Product Change Notification / SYST-02WMHA586

ERRATA - dsPIC33CK256MP508 Family Silicon Errata and Data Sheet Clarification

dsPIC33CK256MP508 Family Silicon Errata and Data Sheet Clarification

FIGURE 1-1: I/O RAMP

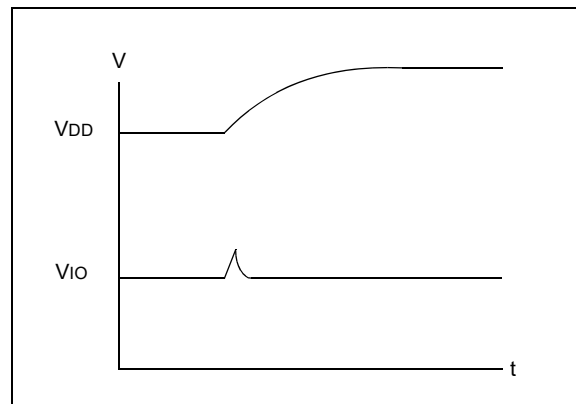
24. Module: I/O

During a fast device power-up when the V_{DD} ramp is less than 4 mS, the I/O pins may drive up to 100 μ A current for a duration of up to 10 μ S (Figure 1-1).

Work around

1. Slow down the V_{DD} ramp time (greater than 4 mS for V_{DD} to ramp 0V to 3.3V).
2. Ensure the circuitry that is connected to the pins can endure this pulse.

Example applications affected may include complementary power switches, where a transient current shoot-through might occur. High-voltage applications with complementary switches should power the high-voltage 200 μ Sec later than powering the dsPIC[®] device to avoid the current shoot-through. This behavior is specific to each device and not affected by aging.
